RTCA Special Committee 209
ATCRBS / Mode S Transponder
Meeting #4

Updated
Review of P1-P3-P4
Accept / Reject Requirements

Presented by R.H. “Bob” Saffell (Rockwell Collins, Inc.)

Description of differences in ATCRBS/Mode S All Call Interrogation P4 pulse duration tolerance between SARPS and DO-181C/ED-73B MOPS

Figure 2: Simplified P4 Acceptance

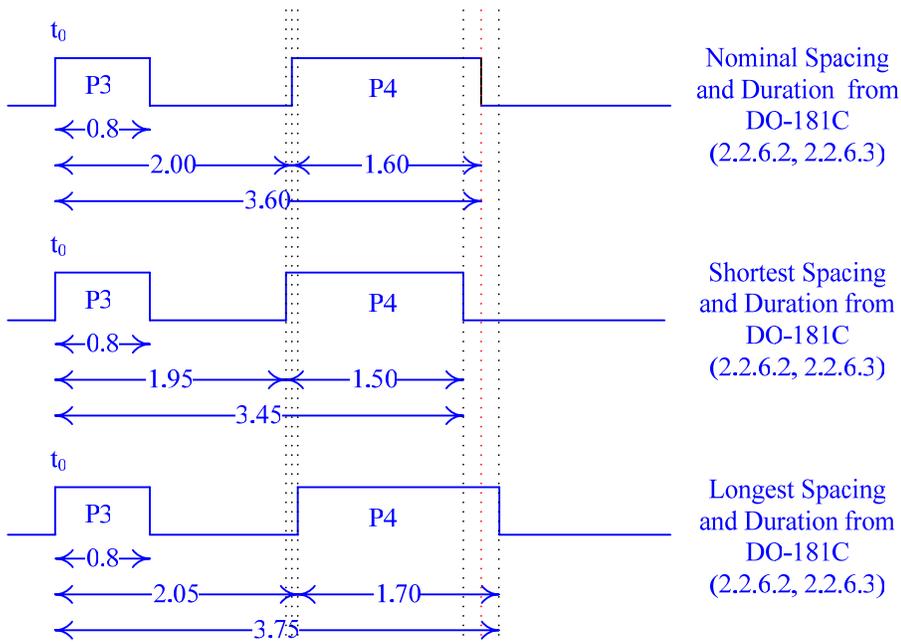
As illustrated in the following Figure 2, you could also take nominal P3-P4 spacing of 2.0 microseconds and nominal P4 duration of 1.6 microseconds, to get 3.6 microseconds. Then subtract 1.0 microseconds for the shortest P4 (1.5), subtract 0.05 microseconds for the shortest P4 spacing (1.95), and you get $3.6 - 1.0 - 0.5 = 3.45$ microseconds.

Likewise, take the same nominal 3.6 microseconds, add 1.0 microseconds for the longest P4 (1.7), add 0.05 for the longest P4 spacing (2.05), and you get $3.6 + 1.0 + 0.05 = 3.75$ microseconds.

SARPs 3.1.2.4.1.2.2.1 places must accept requirement on P4 trailing edge at 3.45 to 3.75 microseconds from the leading edge of P3. As such, the SARPs are placing the trailing edge at the same place that the DO-181C MOPs are as indicated in the above figures.

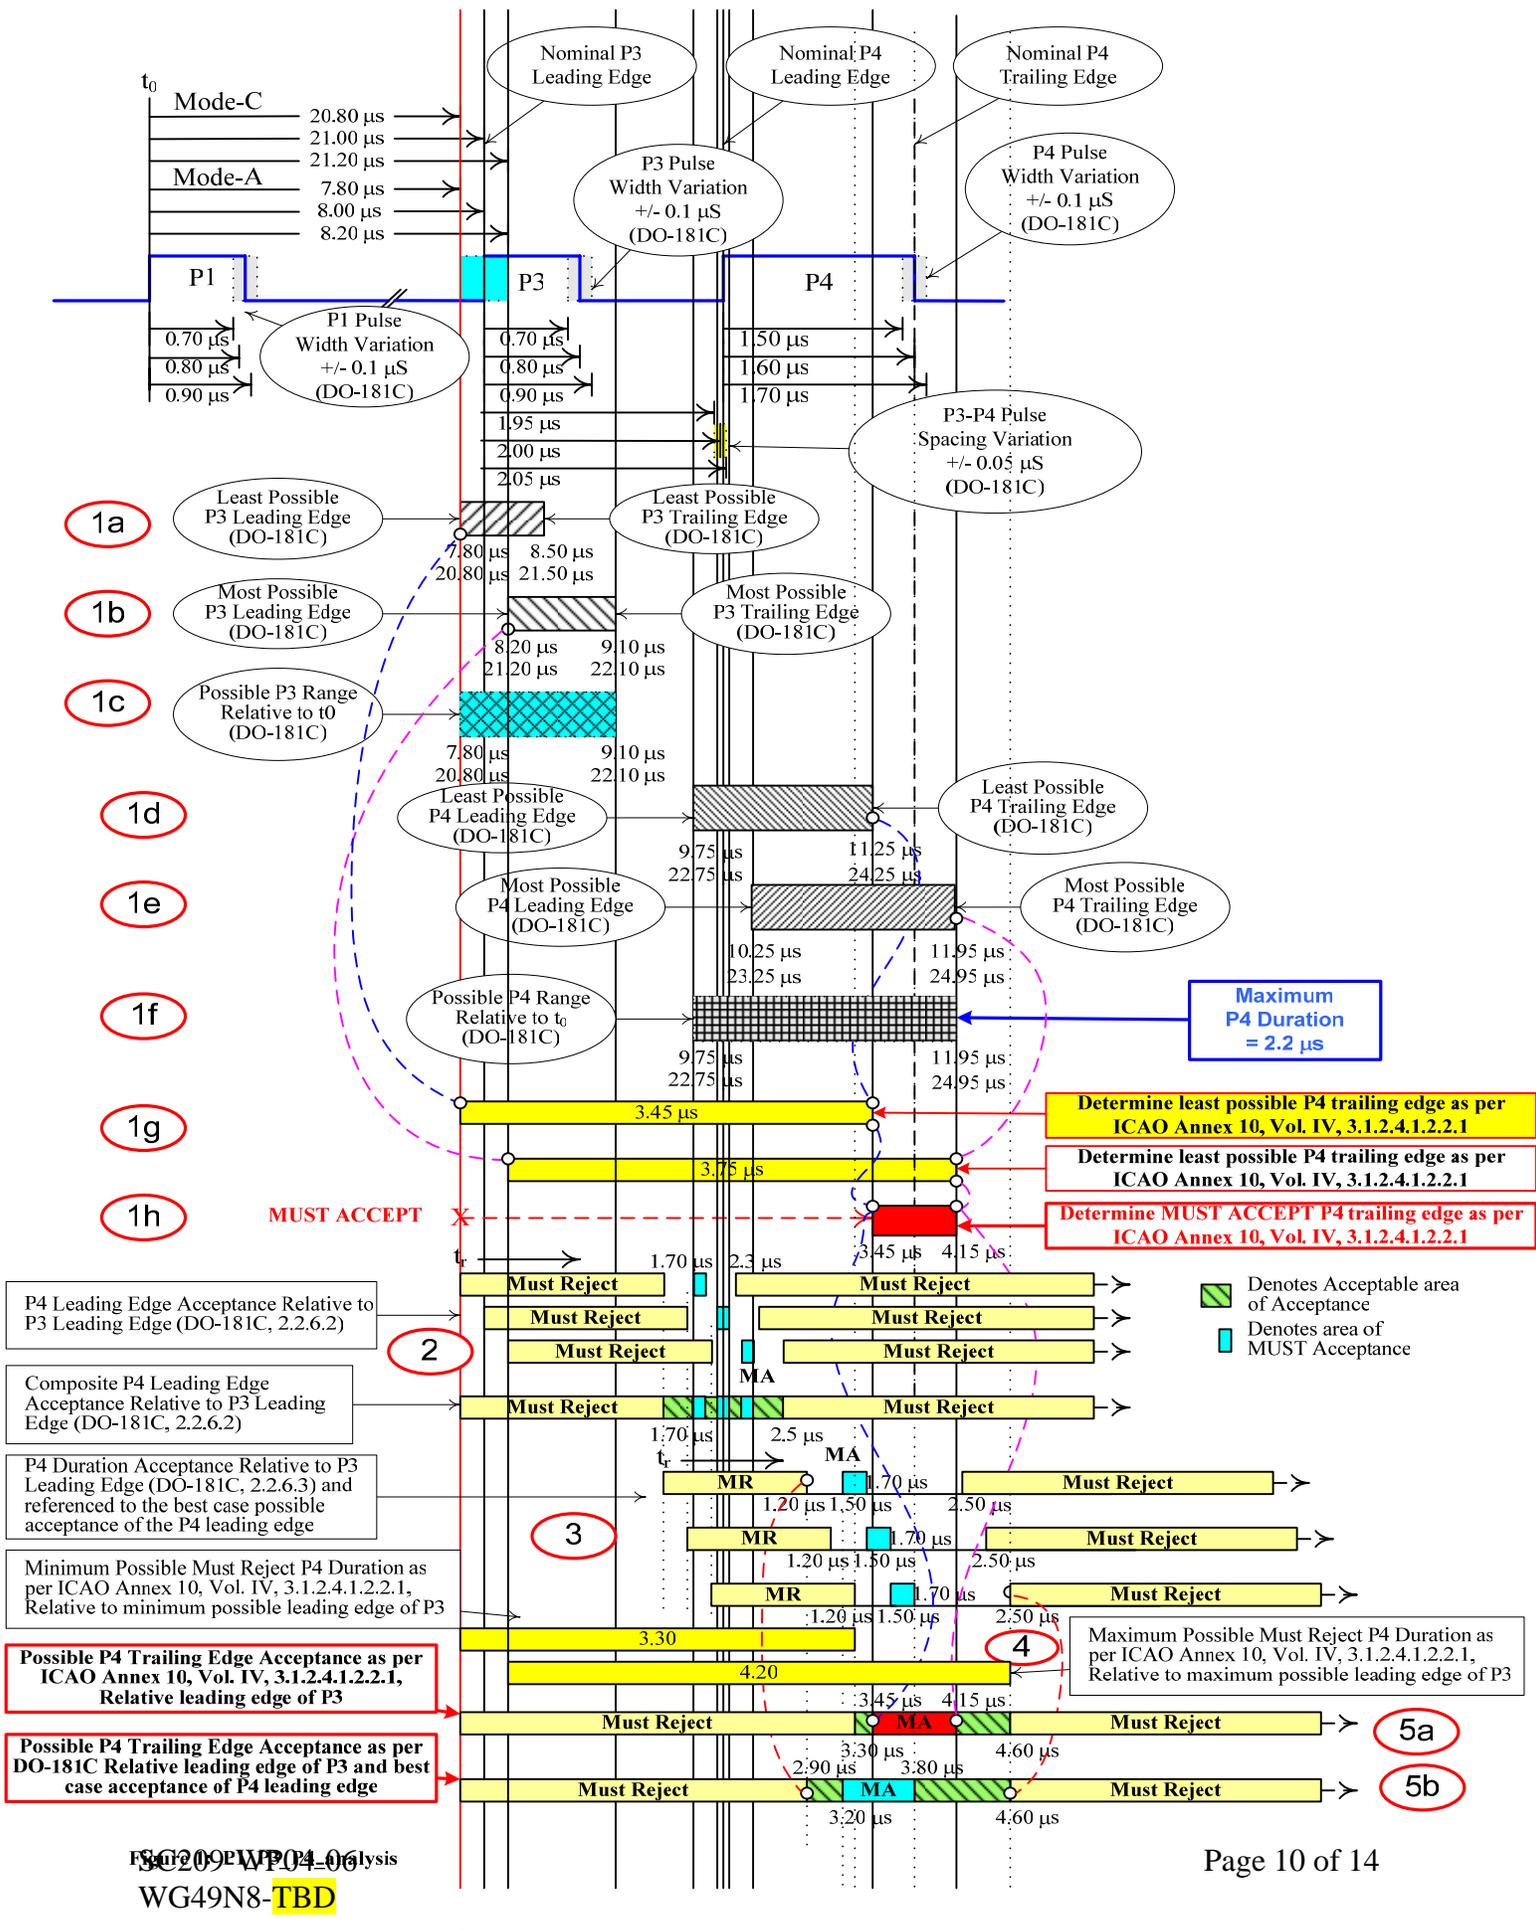
Review of the Figure 1 provided at the end of this document indicates the following:

First, the figure contains Reference Bubbles shown as Red Ellipses with the number/letter inside.

- a. Referring to Bubble 1a on the figure, if the reference time is established at the earliest possible leading edge of P₃ which is at 7.8 microseconds after the leading edge of P₁, then add minimum of 1.95 microseconds for the minimum spacing to the leading edge of P₄, then add 1.5 microseconds for the minimum P₄ duration, you have 11.25 microseconds (Mode-A) for the least possible trailing edge time of P₄, or 3.45 microseconds after the leading edge of P₃. **(Reference Bubble 1d and 1h)**

This same result appears to be obtained directly in ICAO by adding 3.45 microseconds to the earliest leading edge of P3 at 7.8 microseconds, resulting in 11.25 microseconds to the earliest possible trailing edge of P4 for Mode-A interrogations. (**Reference Bubble 1g and 1h**)

- b. Likewise, referring to Bubble 1b on the figure, if the reference time is established at the latest possible leading edge of P3 which is 8.2 microseconds after the leading edge of P1, then add the maximum of 2.05 microseconds for the maximum spacing to the leading edge of P4, then add 1.7 microseconds for the maximum P4 duration, you have 11.95 microseconds (Mode-A) for the most possible trailing edge time of P4, or 3.75 microseconds after the leading edge of P3. (**Reference Bubble 1e and 1h**)

This same result appears to be obtained directly in ICAO by adding 3.75 microseconds to the latest leading edge of P3 at 8.2 microseconds, resulting in 11.95 microseconds to the latest possible trailing edge of P4 for Mode-A interrogations. (**Reference Bubble 1g and 1h**)

Note: *The time of 4.15 microseconds shown for Bubble 1h is actually 3.75 microseconds after the latest leading edge of P3 which occurs at 8.2 microseconds.*

Referring to Figure 1, below, lines indicated by bubble **3** were inserted to show the duration of P4 in accordance with RTCA DO-181C. Lines indicated by bubble **4** were inserted to show the trailing edge of P4 in accordance with ICAO Annex 10.

Virtually all possible combinations were tried in order to get the Must Reject Criteria to line up with those of ICAO Annex 10, but to no avail. In fact, the line indicated by bubble **5b** would indicate that the trailing edge of P4 could occur anywhere between 2.90 and 4.60 microseconds after the leading edge of P3. Needless to say, this does not agree with ICAO Annex 10 which requires that the trailing edge occur between 3.30 and 4.20 microseconds after the leading edge of P3, as indicated by the Figure 1 lines indicated by bubble **4**.

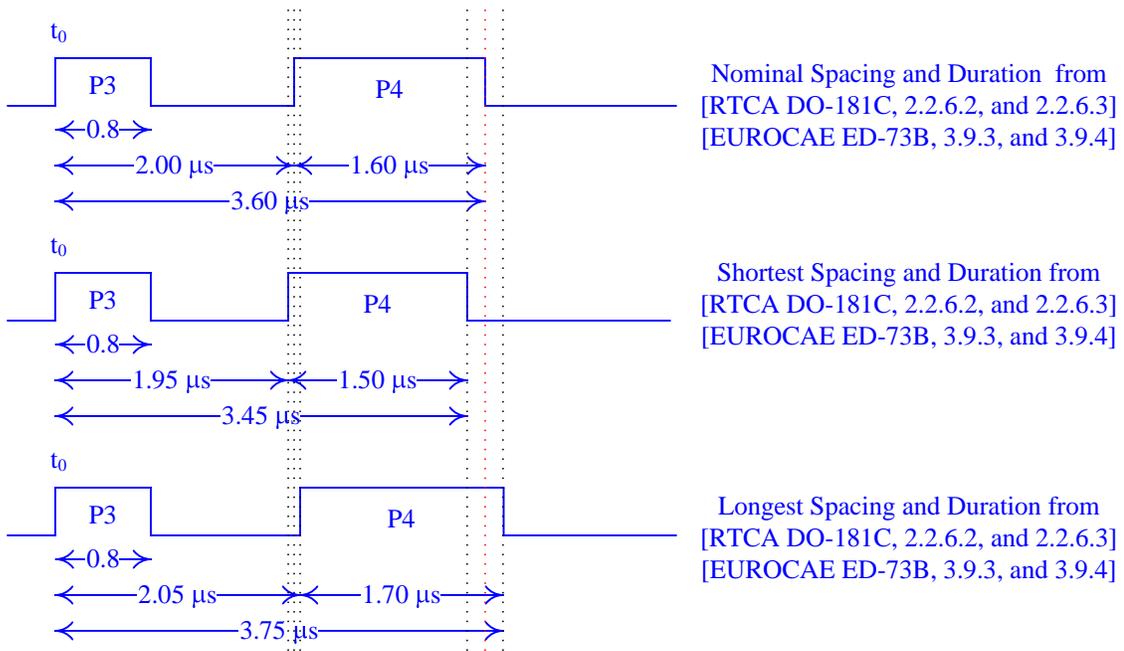
Note 1: ICAO Annex 10, Volume IV, section 3.1.2.4.1.2.2.1 (e.g., SARPs) requires Mode A/C/S all-call interrogation acceptance relative to the trailing edge of P4. Must accept criteria requires that the trailing edge of P4 be between 3.45 and 3.75 microseconds after the leading edge of P3. The following figure applies P3 – P4 must accept spacing requirements along with P4 must accept duration requirements to demonstrate that the resulting P4 trailing edge obtained by the MOPs is equivalent to that referenced by the SARPs.

Effectively, P3 – P4 nominal spacing of 2.0 microseconds plus nominal P4 duration of 1.6 microseconds, results in a nominal P4 trailing edge of 3.6 microseconds. Subtract 1.0 microseconds for the shortest P4, subtract 0.05 microseconds for the shortest P3 - P4 spacing, and the resulting shortest P4 trailing edge is 3.45 microseconds after the leading edge of P3. Next, return to the nominal P4 trailing edge at 3.6 microseconds, add 1.0 microseconds for the longest P4, add 0.05 microseconds for the longest P3 – P4 spacing, and the resulting longest P4 trailing edge is 3.75 microseconds after the leading edge of P3.

Therefore, EUROCAE WG-49 and RTCA SC-209 may want to consider adding the following two notes directly after RTCA DO-181C, section 2.2.6.3 and after EUROCAE ED-73B, section 3.9.4. Alternatively, the Notes should be provided in an appendix and be referenced by the applicable sections of DO-181C and ED-73B.

ICAO Annex 10 Minimum P4 Trailing Edge Rejection

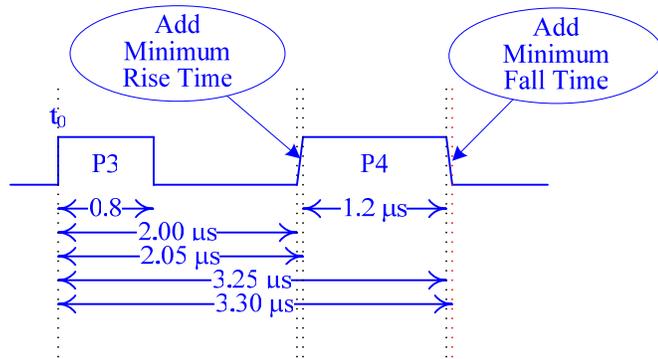
Note 2: ICAO Annex 10, Volume IV, section 3.1.2.4.1.2.2.1 (e.g., SARPs) requires Mode A/C/S all-call interrogation rejection relative to the trailing edge of P4. Must reject criteria requires that the trailing edge of P4 be no earlier than 3.30 microseconds and no later than 4.20 microseconds after the leading edge of P3. The following figure applies P3 – P4 nominal spacing, minimum P4 duration, and minimum rise and fall times to establish the rejection criteria that the trailing edge of P4 be no earlier than 3.30 microseconds after the leading edge of P3. The figure further applies P3 - P4 nominal spacing, maximum P4, and maximum rise and fall times to establish the rejection criteria that the trailing edge of P4 be no later than 4.20 microseconds after the leading edge of P3.

Effectively, start with the nominal P3 – P4 spacing of 2.0 microseconds, add 1.2 microseconds representing minimum duration below which P4 must be rejected as per RTCA DO-181C and EUROCAE ED-73B, then add minimum rise and fall times of 0.05 microseconds each, and the result is 3.30 microseconds from the leading edge of P3 to the trailing edge of P4. If the trailing edge of P4 occurs earlier than 3.30 microseconds, then it must be rejected in accordance to the SARPs.

ICAO Annex 10 Maximum P4 Trailing Edge Rejection

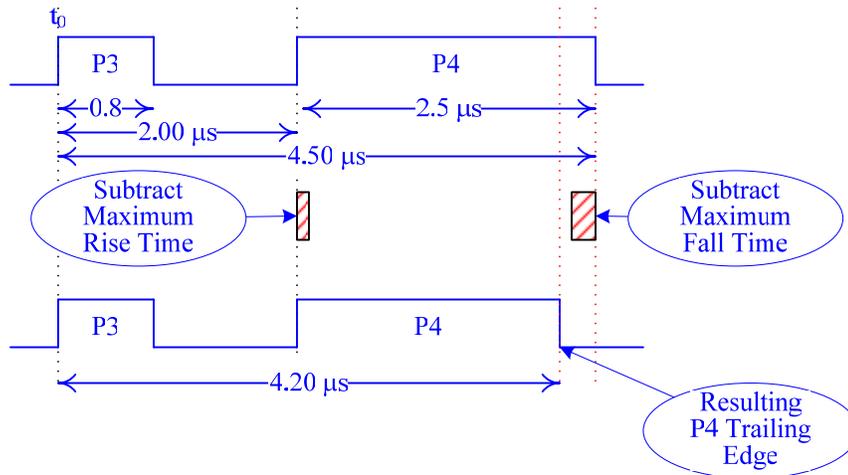
Next, return to the nominal P3 – P4 spacing of 2.0 microseconds, add 2.5 microseconds representing the maximum duration above which P4 must be rejected as per RTCA DO-181C and EUROCAE ED-73B, then subtract the maximum rise and fall times respectively, and the result is 4.20 microseconds from the leading edge of P3 to the trailing edge of P4. If the trailing edge of P4 occurs later than the 4.2 microseconds, then it must be rejected in accordance to the SARPs.
